ADDENDUM NO. 1

Wayne High School Campus Improvements

Fort Wayne Community Schools (FWCS)

November 7, 2025

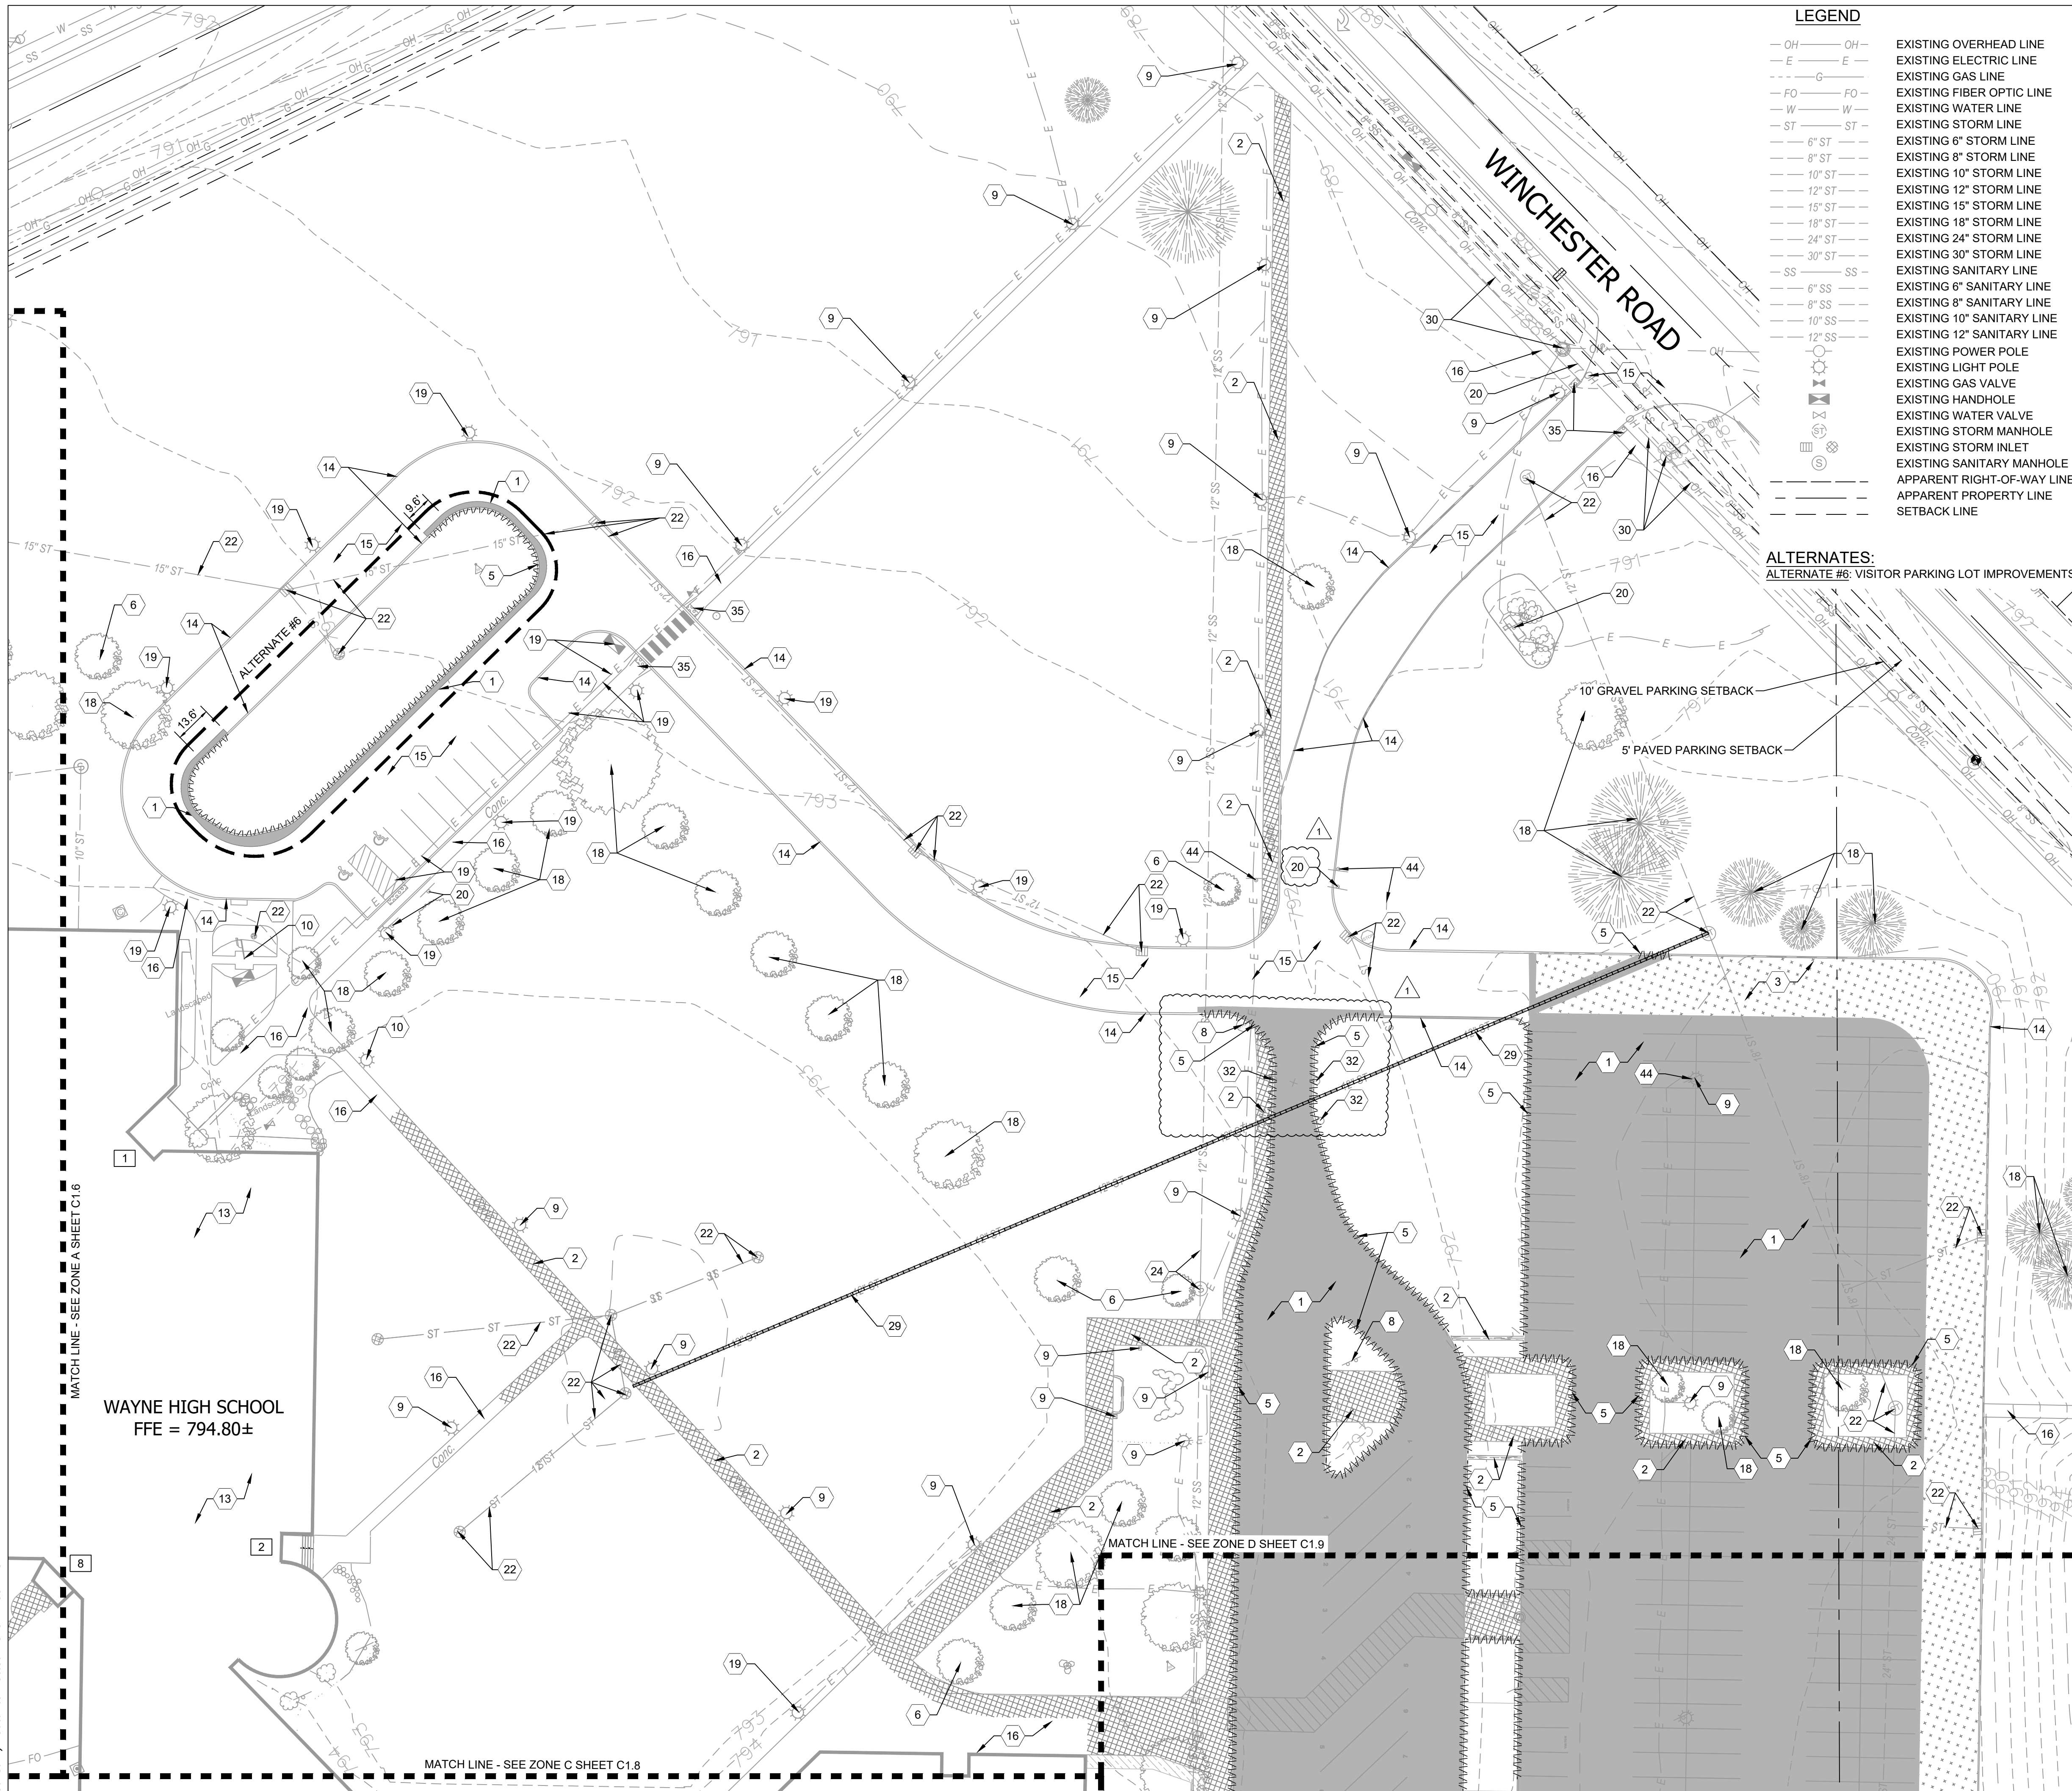
REVISED: Keynote 4 “Remove soil, sod and vegetation as required to meet proposed finished grade.” to “Not Used” and removed Keynote 4 from plan.

REVISED: Limits of full depth replacement and keynote cleanup at school intersection.

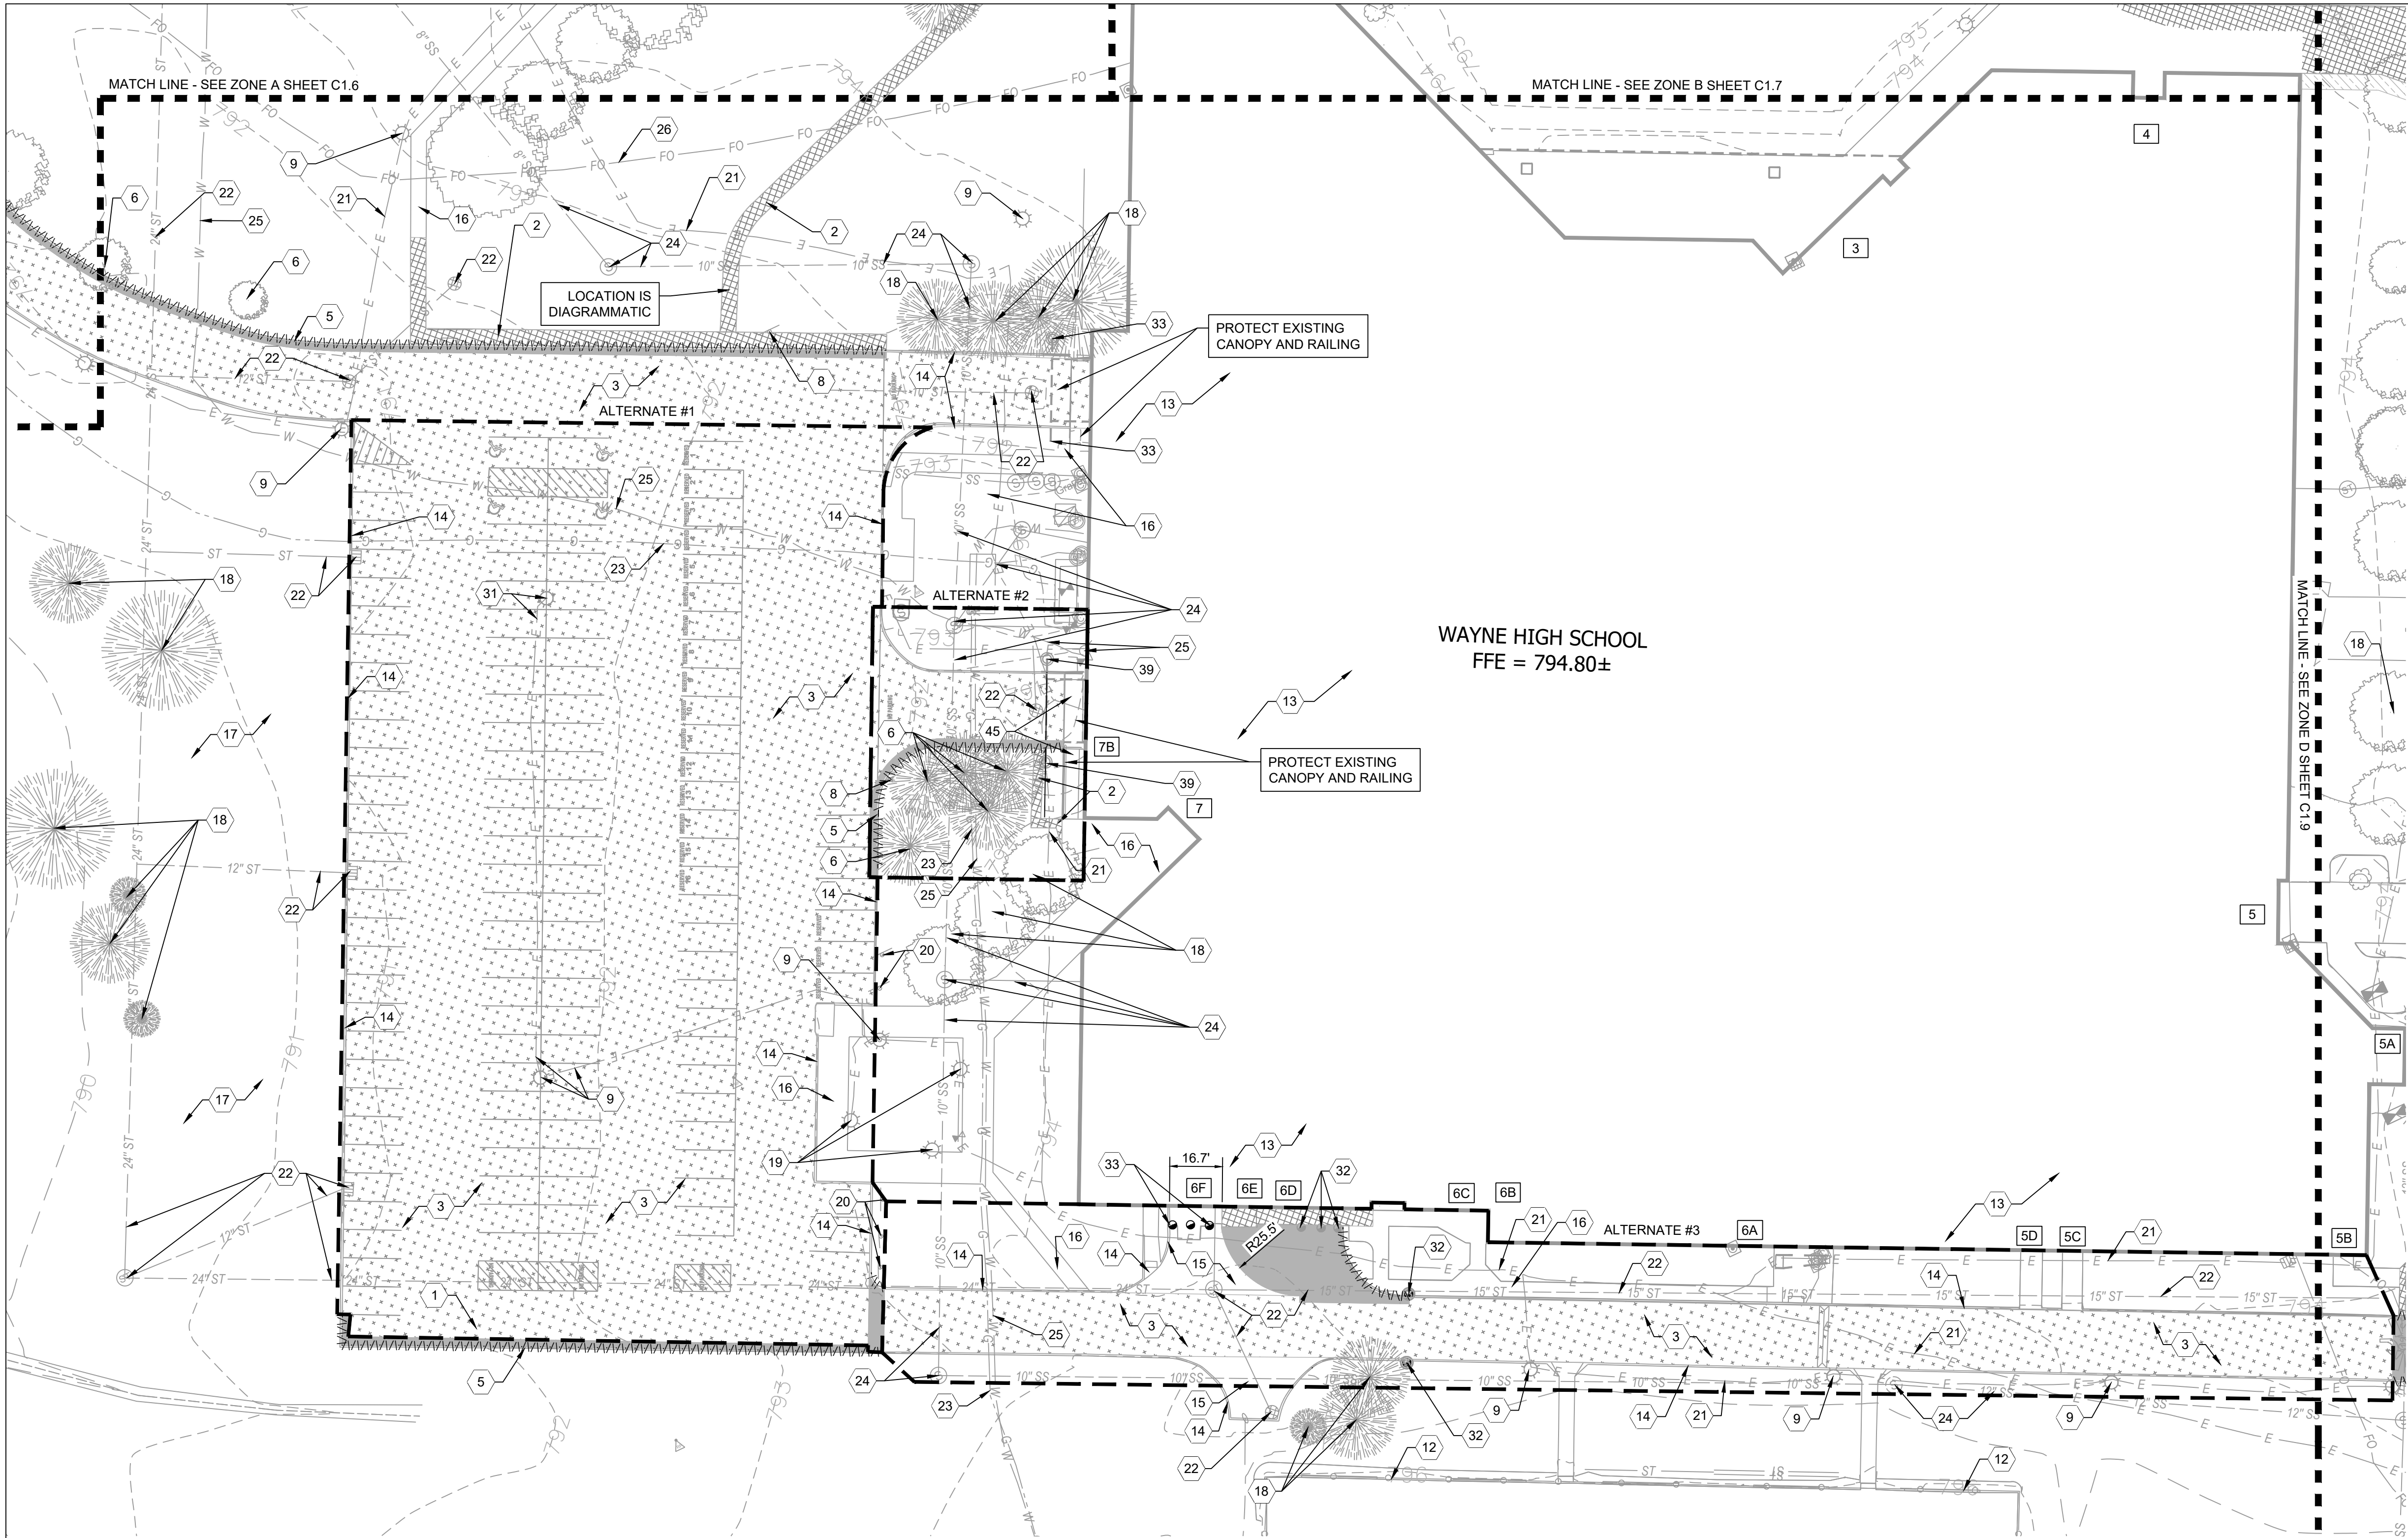
REVISED: Keynote 4 “Remove soil, sod and vegetation as required to meet proposed finished grade.” to “Not Used” and removed Keynote 4 from plan.

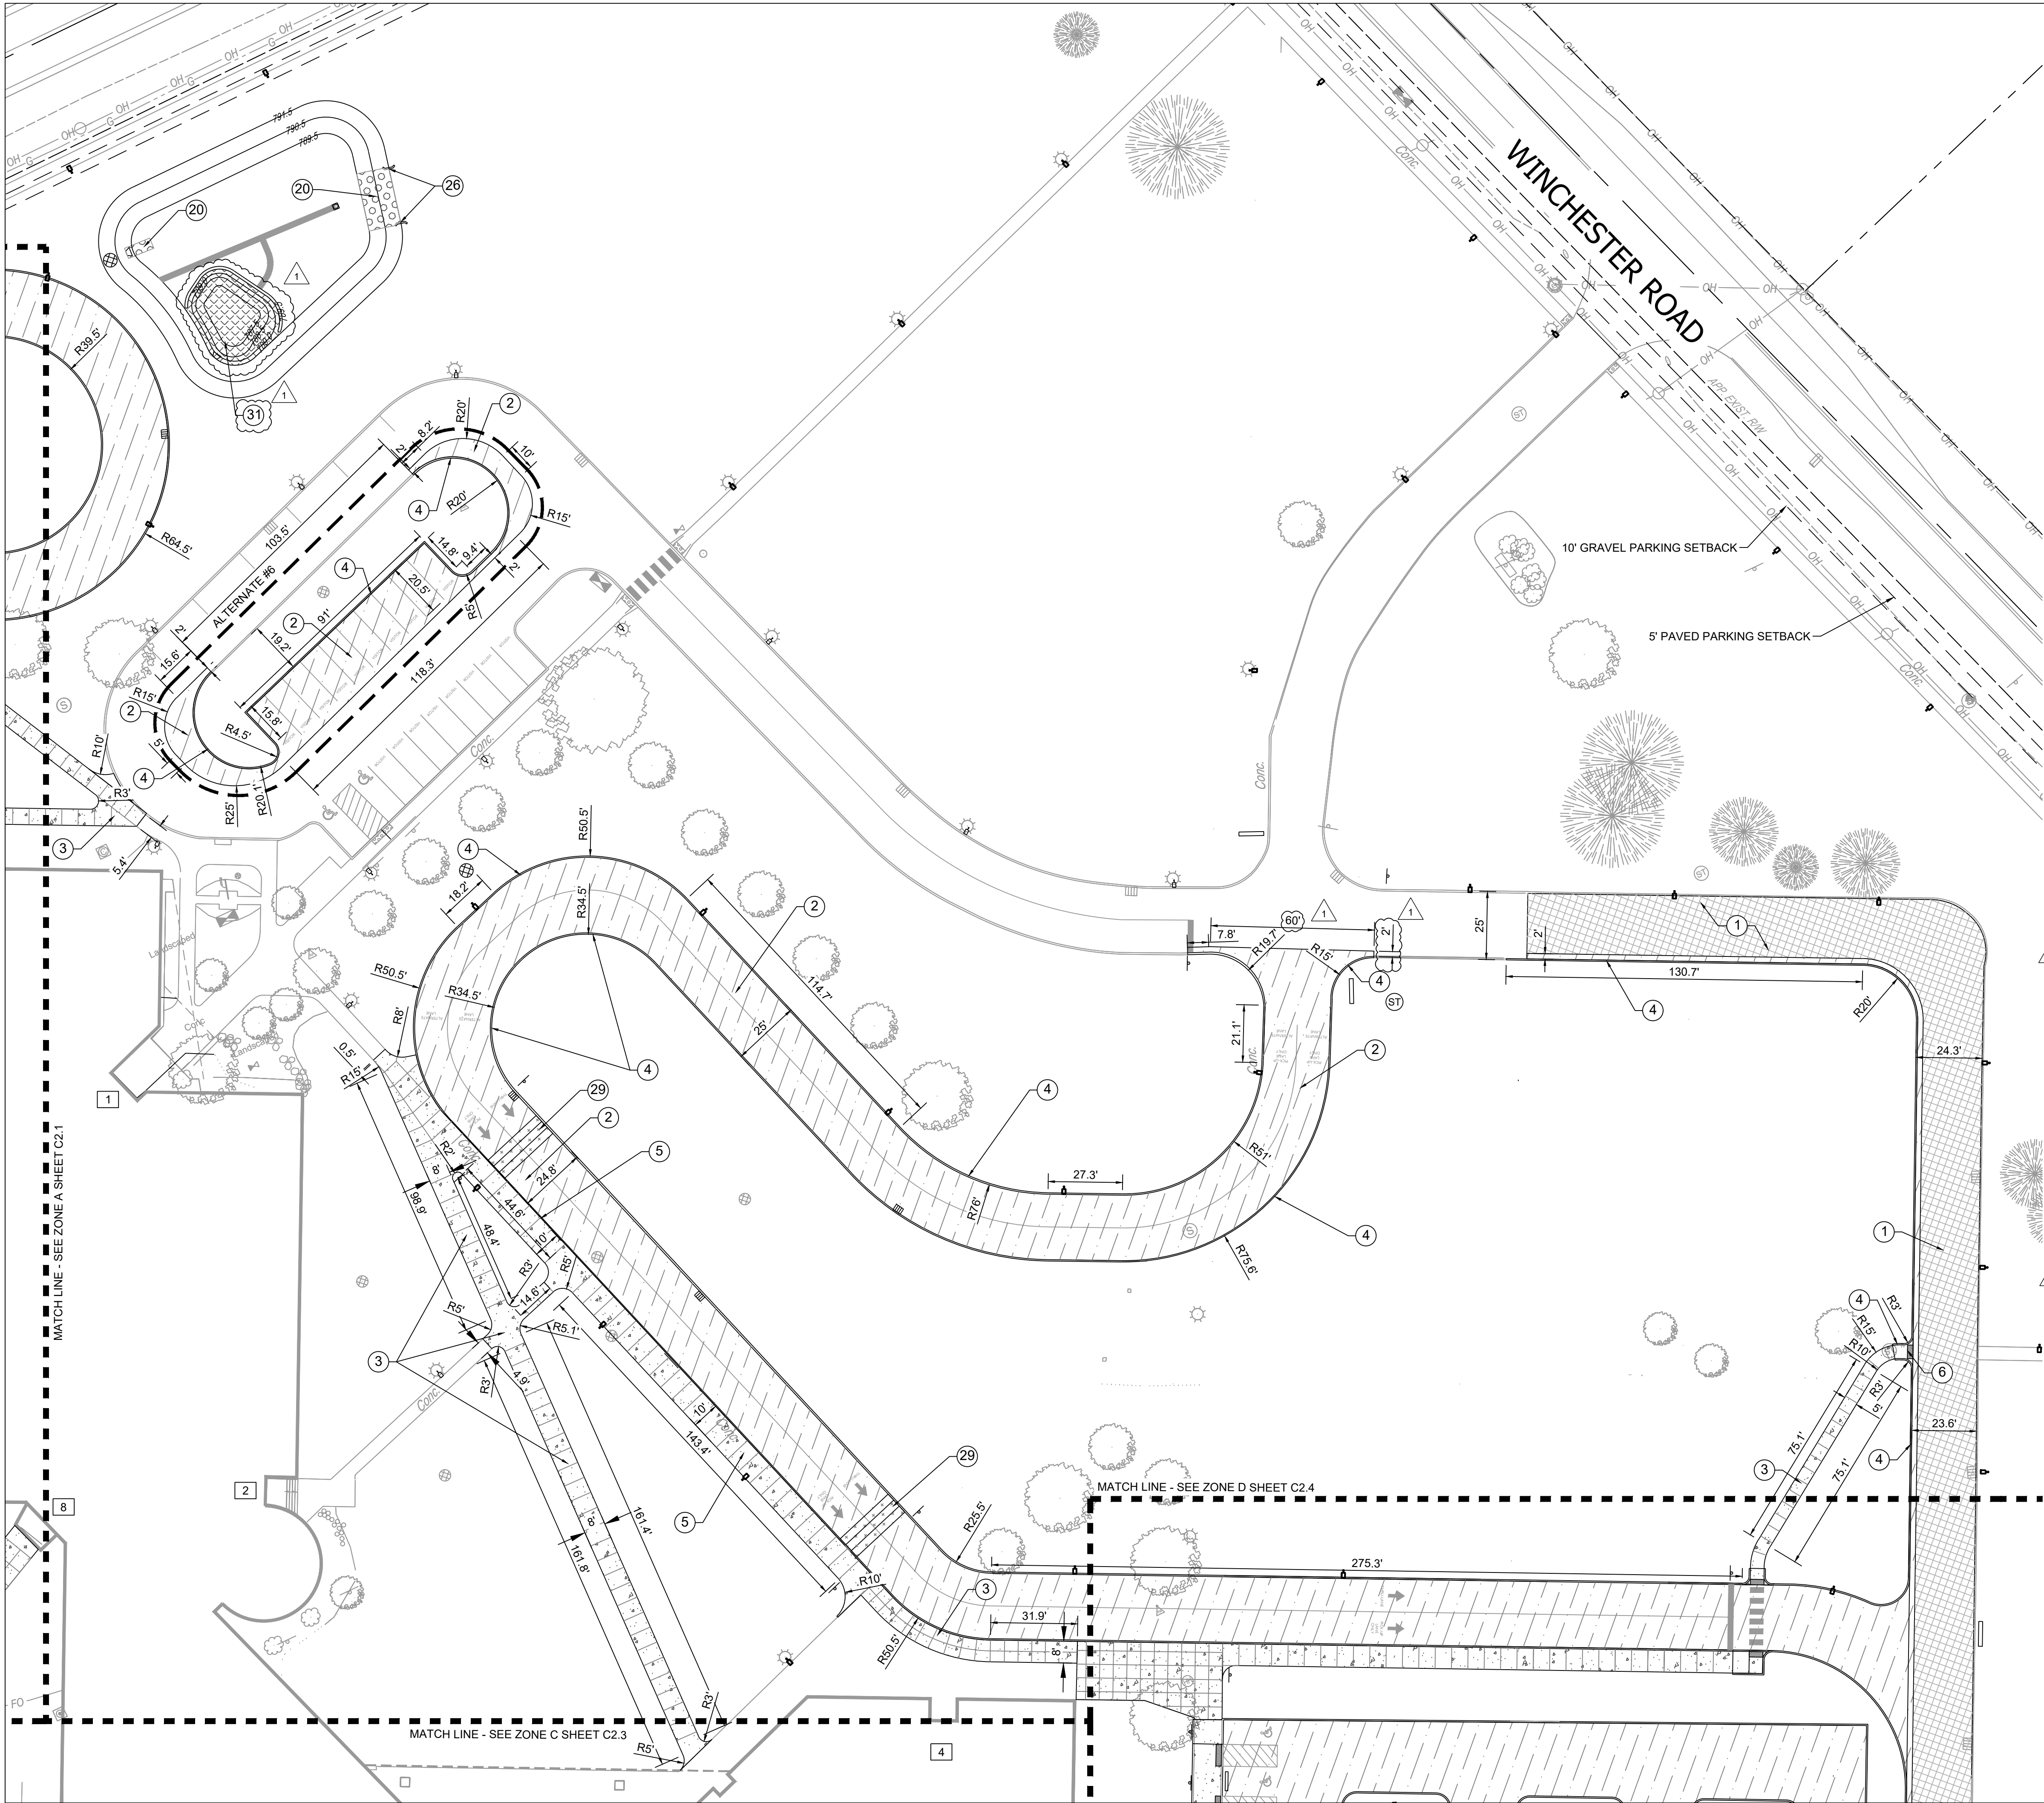
REVISED: Keynote 20 – Erosion Control Surface Flexamat or Approved Equal on Detail Legend to corrected detail (3/C5.3).

ADDED: Erosion Control Turf Reinforcement to Detail Legend.

ADDED: Additional Erosion Control Turf Reinforcement area onto micro pool in detention basin.

REVISED: Limits of full depth replacement and keynote cleanup at school intersection.
